RAMER CREEK ESTATES SUBDIVISION

APPLICATION NUMBER 4 DATE November 15, 2007

REQUEST Subdivision

DETAIL SITE PLAN

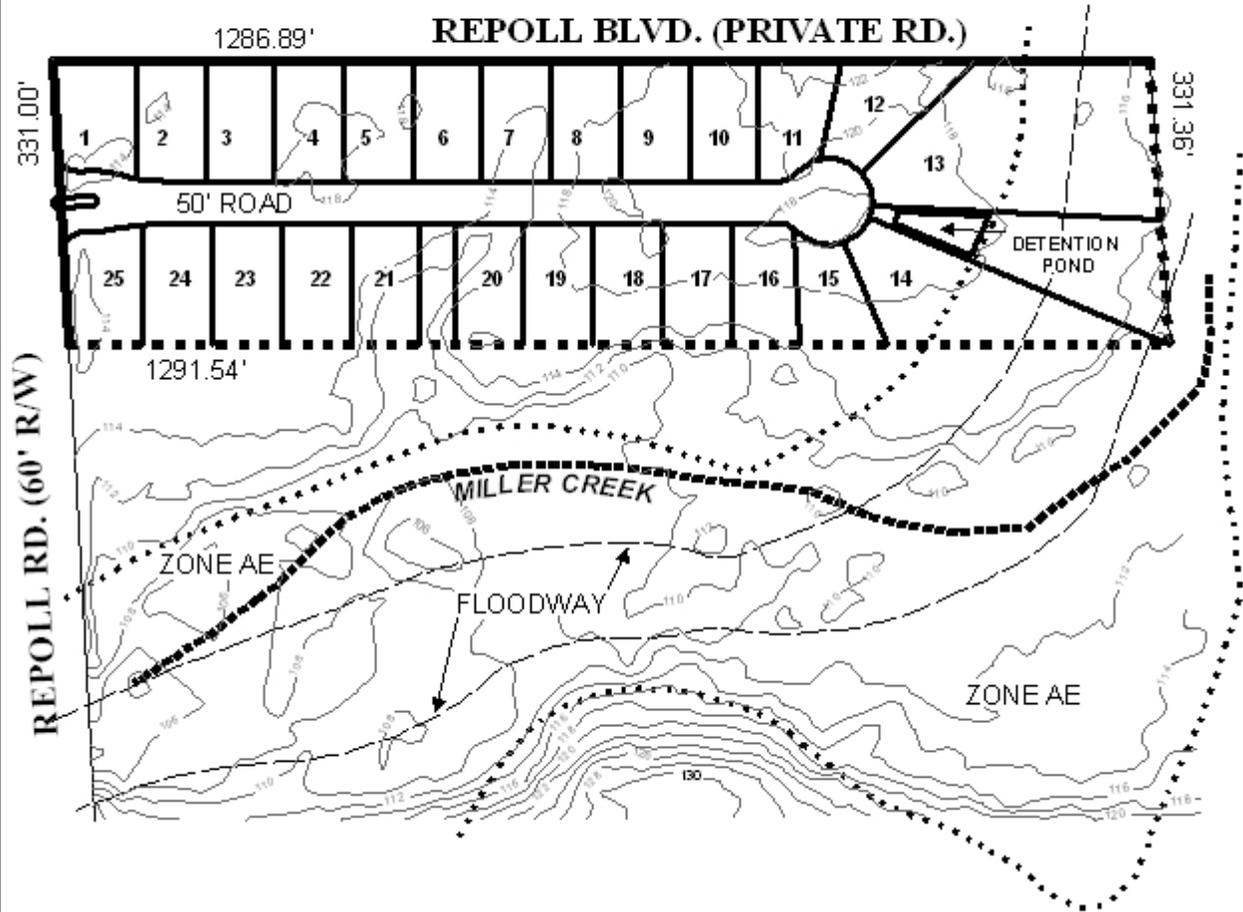
The application proposes a new street, which must be constructed and dedicated to Mobile County Engineering standards prior to signing the Final Plat. Lots 1 and 25 are corner lots; therefore, a note should be placed on the Final Plat limiting each lot to one curb cut each, with the size, design and location to be approved by County Engineering.

The new street, a cul-de-sac proposed for the subdivision, is approximately 940 feet long, which exceeds the 600-foot length recommended in Section V.B.6. of the Subdivision Regulations. To accommodate the proposed length, the plat should be revised to provide a street-stub to the parcel to the South near the midpoint of the proposed street, and to facilitate future connections as the general area is developed.

The requirement for a street-stub to the South is based upon Section V.B.1. of the Subdivision Regulations, which states: "The street layout shall also provide for the future projection into unsubdivided lands adjoining of a sufficient number of streets to provide convenient circulation." The parcel South of the site is approximately 16 acres is likely be the subject of future subdivision applications; hence the recommendation for street-stub should be required.

A retention/detention area is depicted and labeled on the preliminary plat; however, a common area located at the entrance of the proposed subdivision is not labeled. Therefore, the common area should be marked as such, and a note should be placed on the Final Plat stating maintenance of these areas will be the responsibility of the property owners.

No lot sizes in square feet were indicated on the plat; therefore the final plat should be revised to label each lot with its size in square feet, or a table depicting the same information should be provided.

While the site is in the County, the applicant's engineer will be required to certify that the stormwater detention, drainage facilities, and release rate comply with the City of Mobile stormwater and flood control ordinances, prior to the signing and recording of the final plat, if approved. The plat should also be revised to depict lot sizes to be illustrated in square feet either through labeling or the provision of a table on the Final Plat.

The Subdivision Regulations require 15,000 square feet for lots that are served by public water and individual septic systems or 40,000 square feet for lots that are served by individual wells and septic systems; therefore, the need for field lines on each lot is what necessitates the larger lot size. If the development proposes a centralized system, none of the lots will have field lines, thereby eliminating the necessity for the increased size. However, it appears that several lots do not meet the minimum size requirements for developments with access to public water and sanitary sewer as required in Section V.D.2. of the Subdivision Regulations and MAWSS comments that no water or sewer services are available. If the proposed subdivision is served by other facilities, the submission of a letter stating the compliance with V.D.2. should be required.

- 1) provision of street-stubs to the South;
- 2) placement of a note on the final plat stating that maintenance of the common areas, including retention areas, is the responsibility of the home owners;

- 3) labeling each lot with its size in square feet, or a table depicting the same information on the Final Plat;
- 4) placement of a note on the Final Plat stating that Lots 1 and 25 are limited to one curb-cut each with the size, design and location to be approved by County Engineering;

- 5) construction and dedication of the new street to County Engineering standards;
- 6) provision of a certification letter from a licensed engineer to the Planning Section of Urban Development, certifying that the stormwater detention, drainage facilities, and release rate comply with the City of Mobile stormwater and flood control ordinances, prior to the signing and recording of the final plat;

- 7) placement of a note on the plat stating that any lots which are developed commercially and adjoin residentially developed property must provide a buffer, in compliance with Section V.A.7. of the Subdivision Regulations; and

- 8) the submission of a letter stating the compliance of Section V.D.2. of the Subdivision Regulations prior to the signing of the Final Plat or documentation from the developer stating the location and design of a centralized sanitary system to handle the wastewater of the subdivision.

The application was heldover from the October 18th meeting, to allow the applicant to address several issues. A revised plat illustrating the topography of the parcel to the South and addressing all of the deficiencies in the original plat was submitted. Due to the location of a floodway (Miller Creek) that transects the parcel to the south, which was a major concern and reason for the holdover, is illustrated and provides justification for not providing a street stub to the South.

Based on the preceding, the plat meets the requirements of the Subdivision Regulations and is recommended for Tentative Approval, subject to the following conditions:
